Donald C. Cook Nuclear Plant Units 1 and 2
Nuclear Regulatory Commission Approval of Degraded Voltage Protection Backfit Implementation

Attachment: Functional Description of Degraded Voltage System Backfit Modification

Attachment to AEP:NRC:7321
Functional Description of Degraded Voltage System Backfit Modification

**Sketch - Donald C. Cook Nuclear Plant Unit 1 AC Power Supplies
(Unit 2 power supplies are identical except for component designations.)**

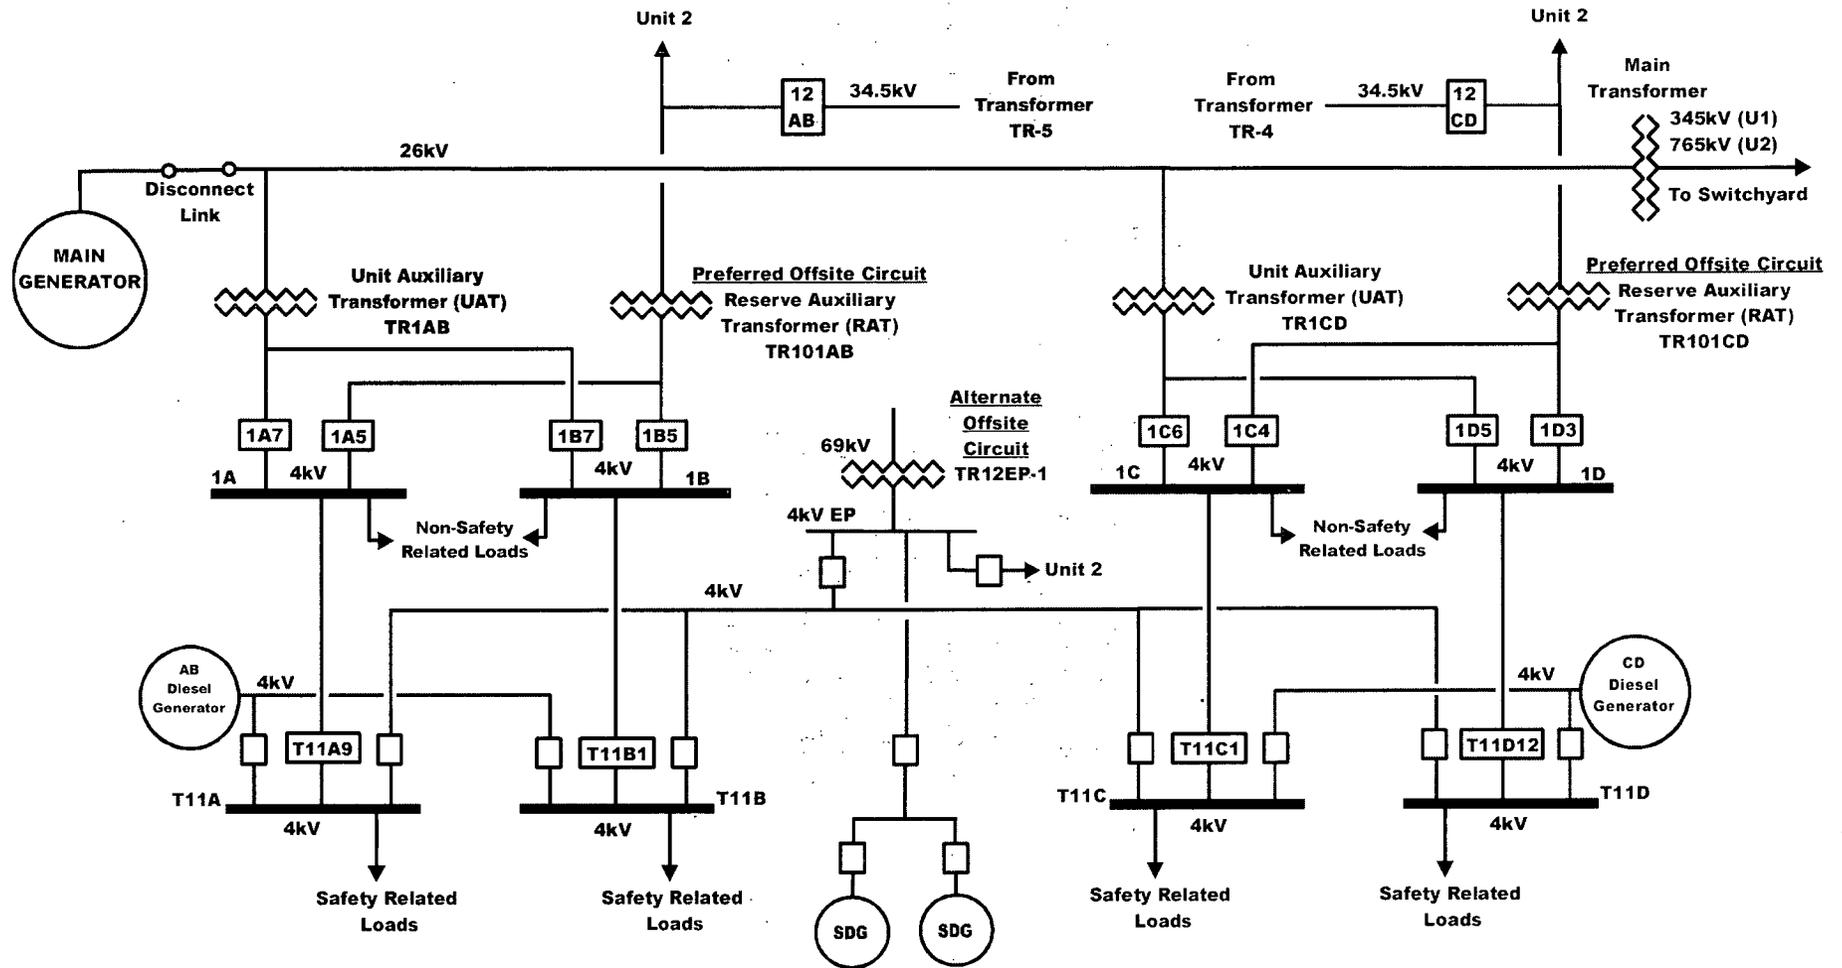
- The RAT feed breaker 1A5, 1B5, 1C4, and 1D3 position function that prevents the degraded voltage relays from tripping breakers T11A9, T11B1, T11C1, and T11D12 will be removed from the breakers' control circuits.
- The degraded voltage protection logic will be modified such that a fast bus transfer from the UATs to the RATs will occur in response to sustained degraded voltage at the monitored

T buses, T11A and T11D, when they are fed from the UATs. The fast bus transfer from the UATs to the RATs will be implemented in a similar manner as the existing fast bus transfer. The bus feed breakers from the UATs and RATs will receive simultaneous trip and close signals respectively, resulting in minimal dead bus time.

- If no accident signal (safety injection or low-low steam generator level) is present and a degraded voltage occurs on the T buses, buses 1A, 1B, 1C, and 1D and the downstream T buses will transfer from the UATs to the RATs after approximately 99 seconds. The degraded voltage condition on the T buses will concurrently initiate the 2 minute time delay. If the degraded voltage on the T buses still exists after the nominal 2 minute delay, breakers T11A9, T11B1, T11C1, and T11D12 will open and initiate transfer to the EDGs.

- If an accident signal (safety injection or low-low steam generator level) is present and a degraded voltage occurs on the T buses, the transfer of the bus 1A, 1B, 1C, and 1D from the UATs to the RATs will be bypassed, resulting in a transfer of the T buses from the UATs directly to the EDGs after the nominal 9 second delay.
